### Proposed Revisions to a Standard Plans Index

Index Number: 630-010

Index Title: Conduit Details - Embedded

Sheet 1: Revised conduit call out to remove material specification.

CONDUIT DETAILS - EMBEDDED

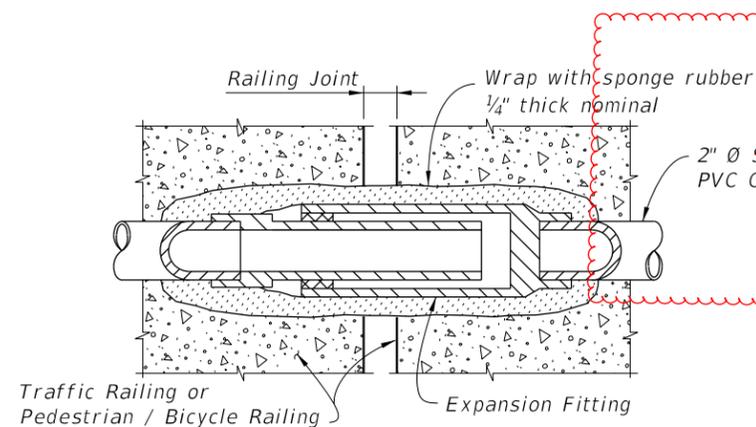
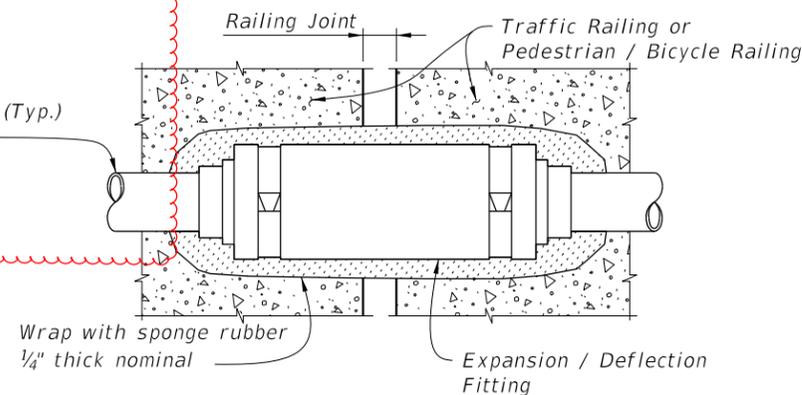
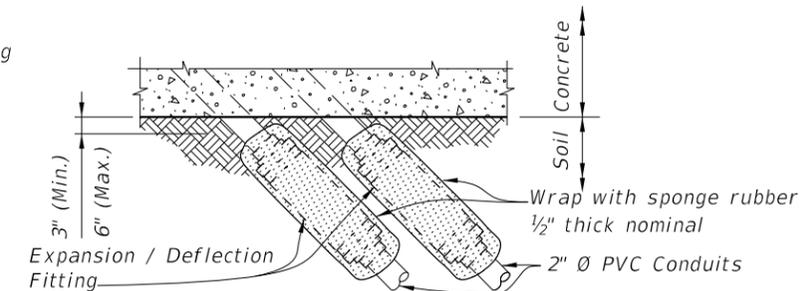
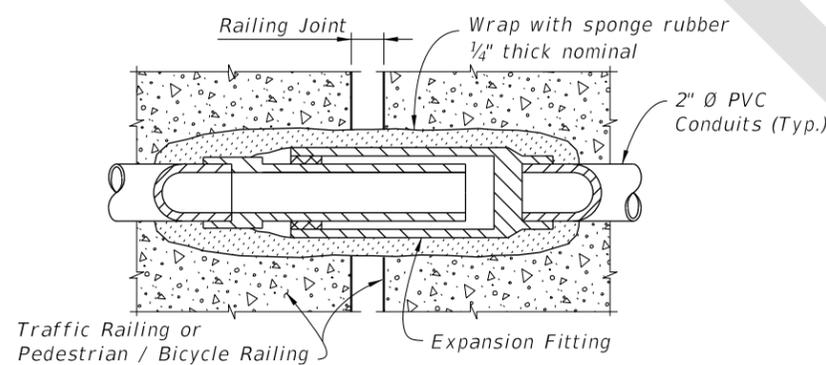
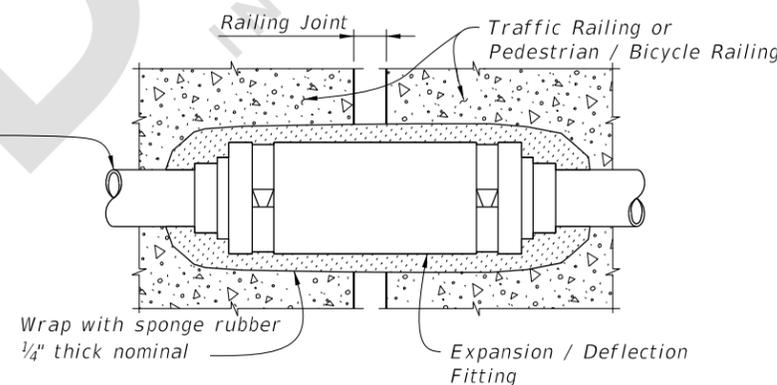
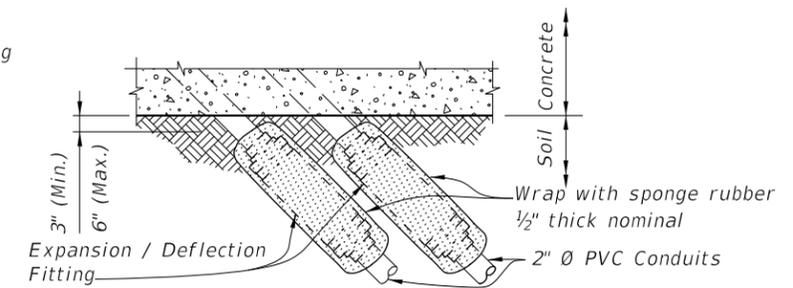
Districts agreed with the proposition at the December 2022 TAG meeting to move from Sch 80 to Sch 40. It was decided to remove the material requirements from the Standards as they should be in the Spec.
